Access Compliance Report

Public Rights-of-Way

(Curb Ramps)

Intersection ID: 4088	Main Street: KENDAN_KNOLL_DR	Cross Street: SANRIDGE_WIND_LN	Location: NW
ADA ID: 7D12FF7B5B3C	Ramp Type: Perp	Initial Pass/Fail: Fail	Overall Compliance: No
Severity Score: 42.5			
Codes/Mitigation Info/Possible Solution		Field Measurements/Component Compliance

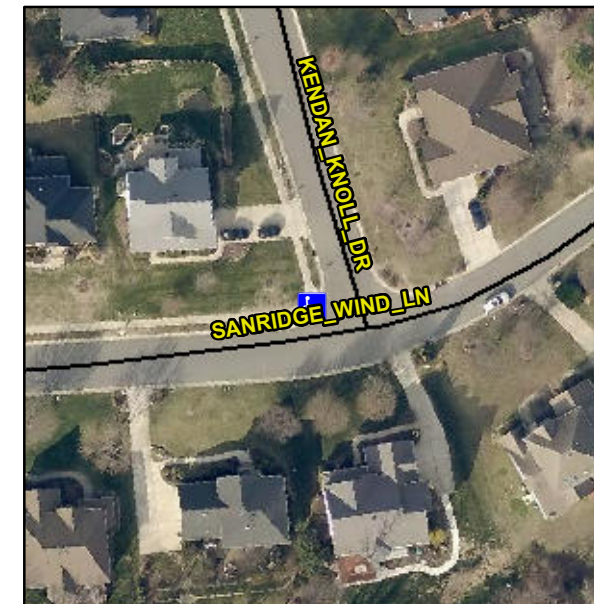
R304.5.1, R304.2.2

Compliance	Description	Data	Compliance	Description	Data
N/A	Ramp Length (in)	52.0	No	Ramp Slope (%)	15.7
No	Ramp Width (in)	32.0	Yes	Ramp XSlope (%)	0.5
N/A	Flare Type LT	N/A	N/A	Flare Type RT	N/A
N/A	Flare Slope LT (%)	N/A	N/A	Flare Slope RT (%)	N/A
N/A	Flare Traversable LT?	N/A	N/A	Flare Traversable RT?	N/A
N/A	Landing Length (in)	N/A	N/A	DWS Provided?	N/A
N/A	Landing Width (in)	N/A	N/A	DWS Contrast?	N/A
N/A	Landing Slope (%)	N/A	N/A	DWS Length (in)	N/A
N/A	Landing X Slope (%)	N/A	N/A	DWS Full Width?	N/A
N/A	Landing Curb? (Y/N)	N/A	N/A	DWS Offset (in)	N/A
N/A	Shared Landing?	N/A			
N/A	Gutter Ponding?	N/A	N/A	Gutter Slope (%)	N/A
N/A	Gutter Lip Ht (in)	N/A	N/A	Gutter X Slope (%)	N/A
N/A	Painted X Walk1?	No	N/A	Painted X Walk2?	N/A
	X Walk 1 Direction	To E		X Walk 2 Direction	N/A
N/A	X Walk 1 Width (in)	N/A	N/A	X Walk 2 Width (in)	N/A
	X Walk 1 Slope (%)	0.3		X Walk 2 Slope (%)	N/A
	X Walk 1 X Slope (%)	0.1		X Walk 2 X Slope (%)	N/A

Remove & Replace Entire Ramp.
